Lord Howe Island
Aerodrome Technical
Inspection 2017

AERODROME TECHNICAL INSPECTION

Lord Howe Island Board

Airport Operation Support Pty Ltd

EXAMPLE FROM 2013 ATI REPORT.

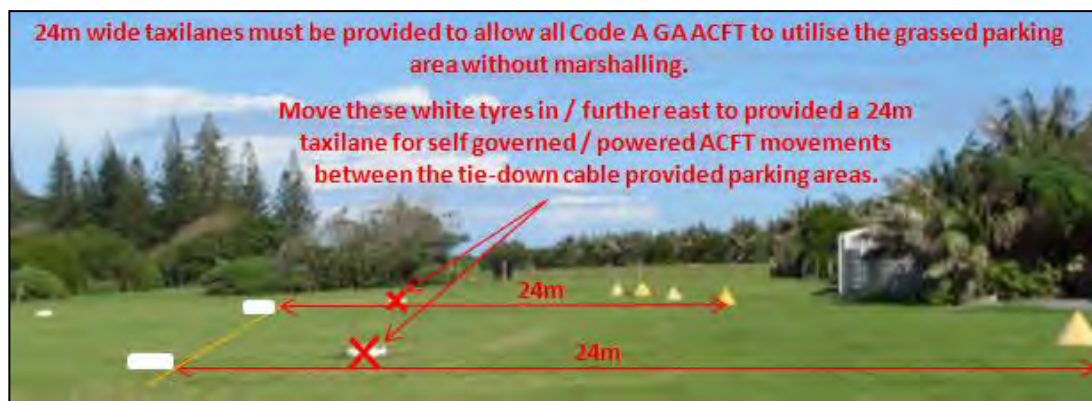
In the 2013 ATI, it was brought to the Board's attention that the painted white tyres (that reveal the tie-down cable locations and therefore parking extents) locate too close the boundary and the RPT apron. It was recommended that the tyres be moved further east to provide a clear 24m wide taxilane along the boundary and clear of the RPT apron.

- The LHIB has acknowledged this and has stated that they intend to improve this in the future.
- It is noted that in all past ATI inspection, no ACFT has ever been observed parking in this area.

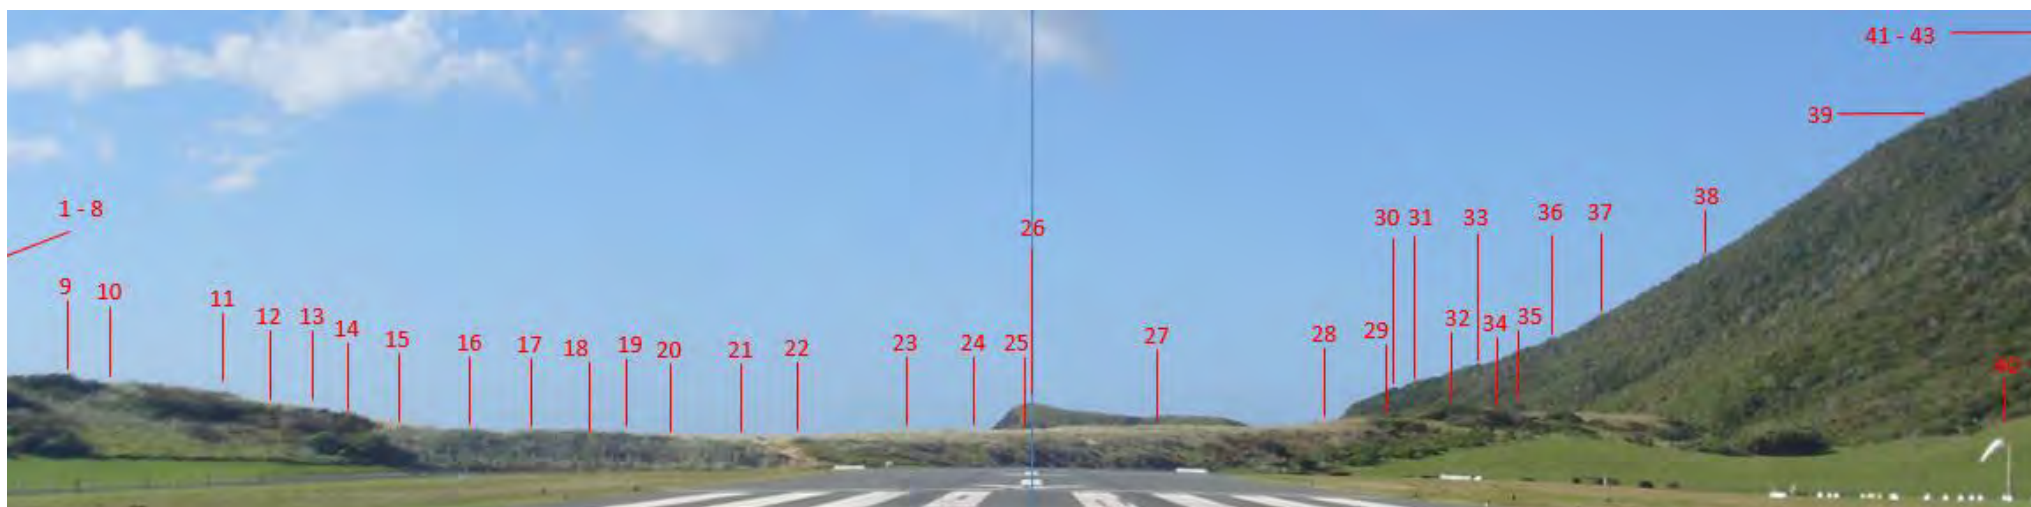
# 38	Intermediate Hill	1123.65	117.45	364.00		--	--	--	--	--					IHS	Infringes 72.65	Not Applic.	--		
# 39	Intermediate Hill	1041.45	181.20	455.70		--	--	--	--	--					IHS	Infringes 136.4	Not Applic.	--		
40	PWI	-33.85	4.33	91.10		--	--	--	--	--					TS	Under 5.11m	Not Applic.	--

# 41	Intermediate Hill	1025.35	241.24	621.30		--	--	--	--	--					IHS	Infringes 196.44	Not Applic.	--		
# 42	Intermediate Hill	661.95	200.05	517.30		--	--	--	--	--					IHS	Infringes 155.25	Not Applic.	--		
LOP 43	Norfolk pines	-324.75	41.07	200.10		--	--	--	--	--					TS	Infringes 10.18m	Not Applic.	--

- Recommendation 7: To lop, remove or re-locate those obstacles found to be infringing the OLS as identified by yellow highlighting and the word “LOP” in the survey result tables within Section 10.2 of this report.
 - APPLICABLE for TKOF 10.
 - APPLICABLE for TKOF 28.

10.2.2 RWY 28 TAKE-OFF (WESTERN END)

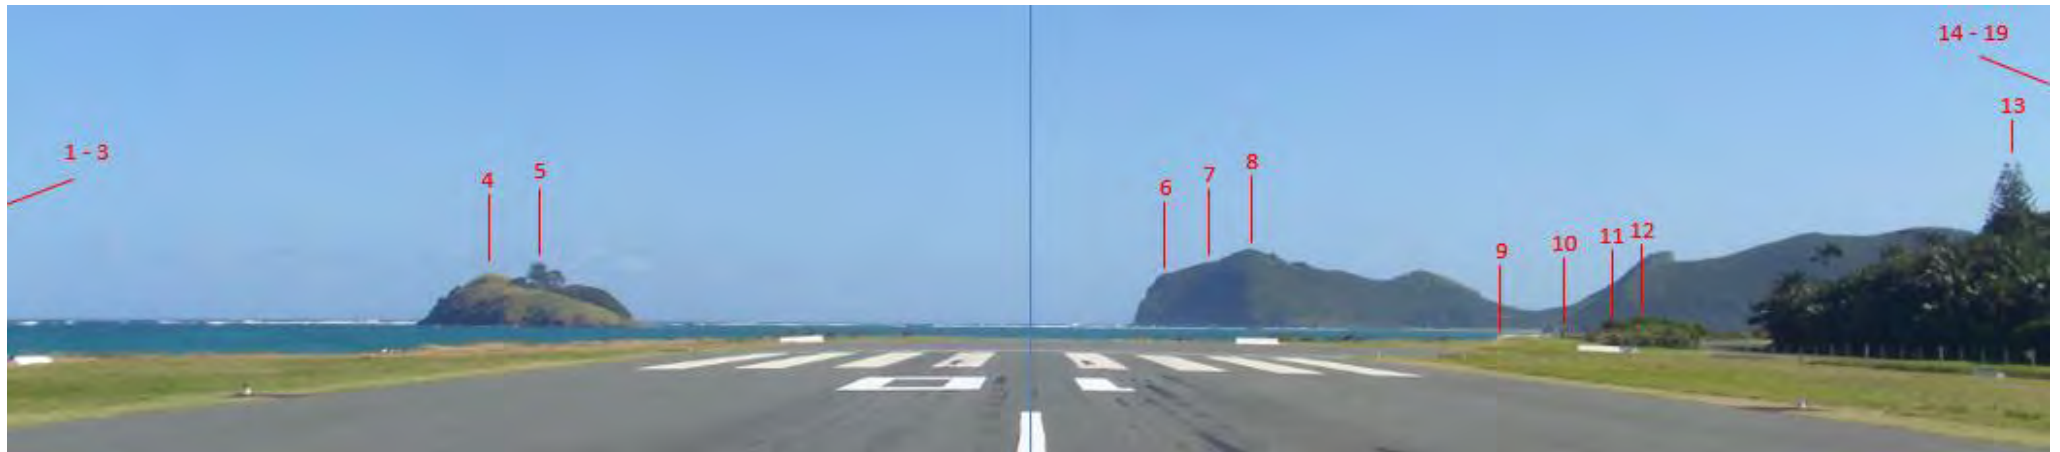
# 17	Transit Hill	146.63	40.20	185.90	--	--	--	--	--	--						TS	Infringes 11.53m	Not Applic.	--
18	Bush	-274.33	0.68	57.42	--	--	--	--	--	--						TS	Under 1.96m	Not Applic.	--

# 19	Transit Hill	-10.07	64.18	221.30	--	--	--	--	--	--						TS	Infringes 28.91m	Not Applic.	--
